Application Number SSD-101842729

Proposal Detailed State Significant Development Application for a residential development with in-fill affordable housing

Location 2-6 Conway Avenue, 15-15A Fernleigh Avenue & 38-40 Carlisle Street, Rose Bay

Figure 4: Annotated Section A-A
Source: Section MHNDUNION, Annotations Council Staff

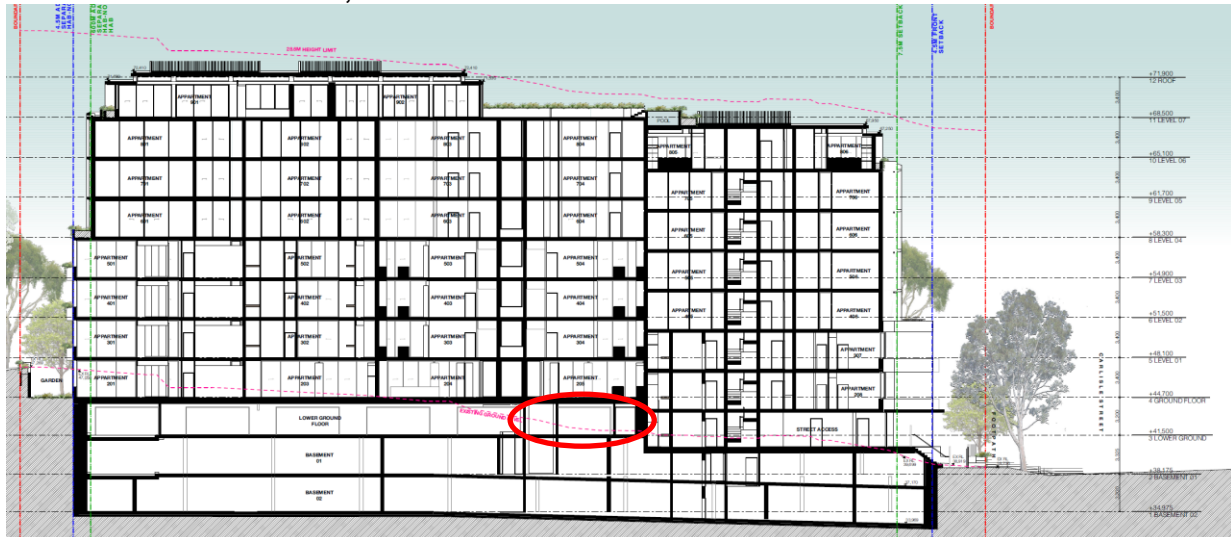
However, the FSR is incorrectly calculated. Specifically, an area of the lower ground level is not predominantly located below ground level (existing) and the first floor level of the storey immediately above is more than 1m above ground level. This area of the lower ground floor level is therefore not defined as a basement under the WLEP 2014 definition. This area is circled in red on the section in Figure 4 below.

The above ground area of the lower ground level contains bin storage, storage areas, a car wash space, mail room and horizontal circulation. All these areas are considered to constitute gross floor area. It is noted that storage, garbage and services are only excluded from GFA if they are located at basement level.

The exhibition documentation fails to provide sufficient information to enable an understanding of the extent of the FSR non-compliance and the associated impacts. It is requested that the SSDA is re-exhibited with sufficient information to ensure the community can comment on the proposed variation.
